Re: Nine Mile Point Unit 2
Docket No. 50-410

A potential deficiency involving the possible future movement of the Nine Mile Point Unit 2 Radwaste Building geologic feature was initially reported by telephone to Mr. A.C. Cerne of your staff on December 4, 1979. Since the investigation of the Radwaste Building geologic feature has not been completed, this letter serves as an interim report.

Attached is our response to the Nuclear Regulatory Commission's Office of Nuclear Reactor Regulation's geologic information Request Q361.1 for Nine Mile Point Unit 2. This response provides the current status of the investigation of the Radwaste Building geologic feature.

Q361.1

FIGURE 361.1-1

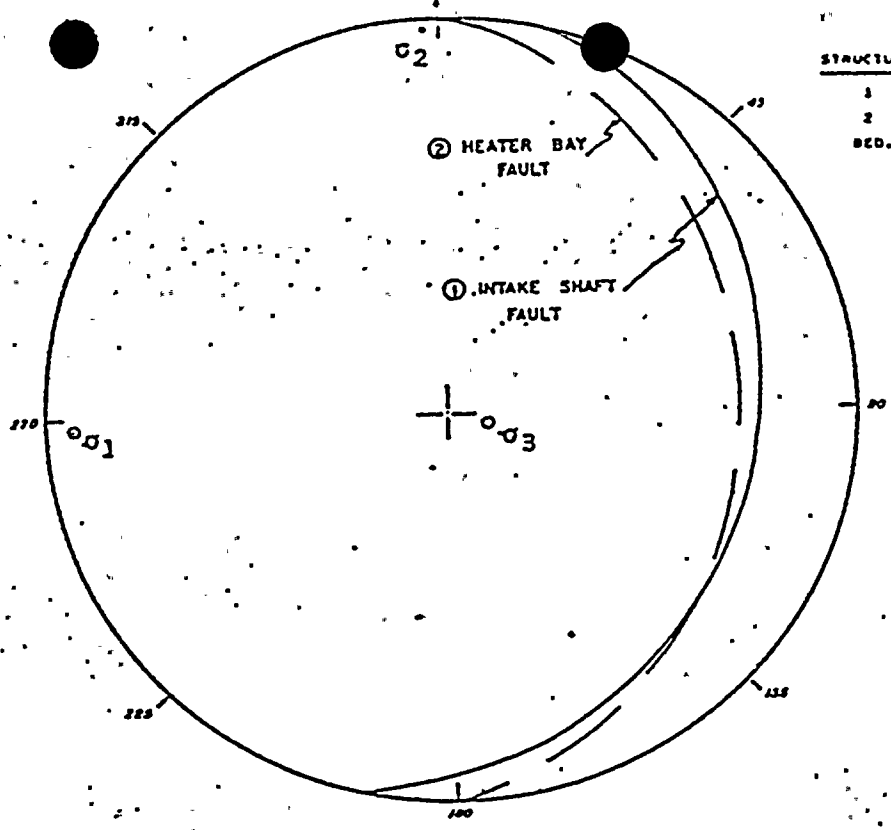
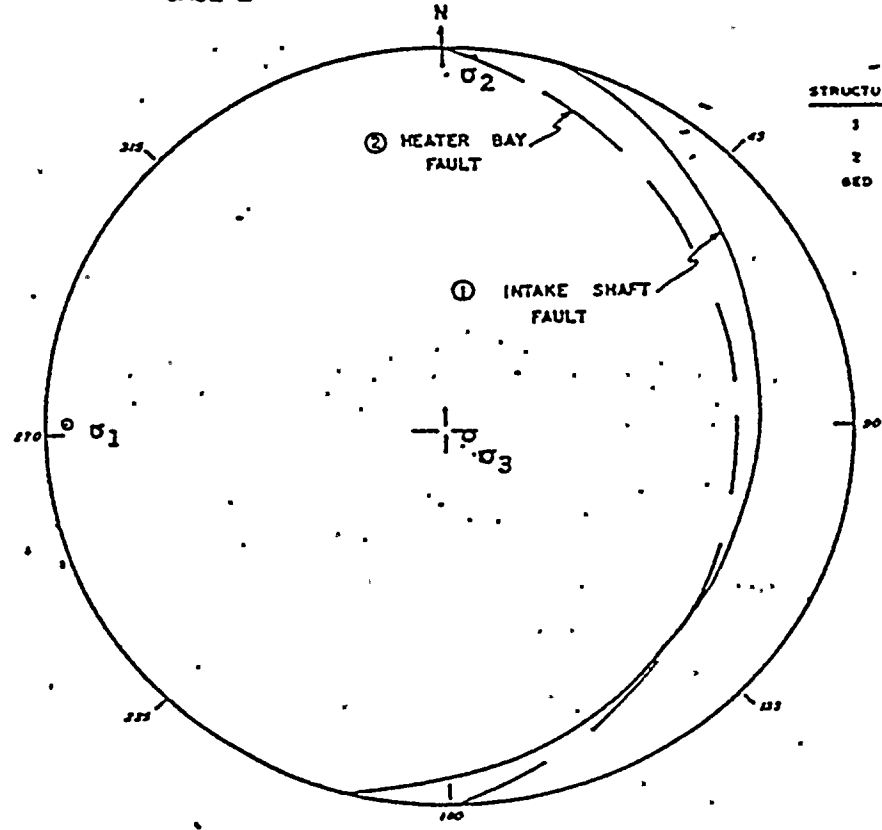
- d. A fourth line of evidence given is that the necessary stress orientation for causing most of the geologic structures in the main power block island are probably similar in orientation to those responsible for the development of the regional fracture pattern that is believed to have occurred during the Late Paleozoic. However, the current stress regime at this location, based on in situ measurements made during this investigation, are relatively high and also commensurate with the orientations, attitudes and sense of last movements along the thrust faults in the heater bay, radwaste building and the intake shaft. Expand your discussion of the origin of these features including all the data that indicate age and causes of the deformation. Perform an analysis to assess whether or not current existing stresses in the vicinity of Unit 2 will produce adjustment-type movements on the low angle thrust faults. Among the factors to be considered in this analysis are: orientations and magnitudes of stresses, pore pressures, swelling characteristics of bedrock, and effective stresses normal to the fault plane.

The stress tensor determined from strain-relief measurements in the Intake Shaft (NMPC, Vol. III, 1978) is commensurate with the orientation and sense of the slip vector indicated by the displacements identified along the Radwaste Fault and the east-dipping shaft fault. The stability of these faults has been evaluated as shown on Figure 361.1-1. For two cases (Table 3-18, Vol. III, NMPC, 1978) the normal stress and shear stress on the faults and on bedding were resolved from the three principal stresses, and the results are tabulated for each case (Figure 361.1-1).

Comparison of the computed values of shear stress with the shear strength for the east-dipping inclined faults reveals they are approximately equal if friction and cohesion parameters from laboratory testing are applied to analysis of the entire fault as a hypothetical, idealized plane. The irregular geometry of the fault (ranging in dip from 0 to 50 degrees) and the asperities on the fault plane contribute to the stability of the faults.
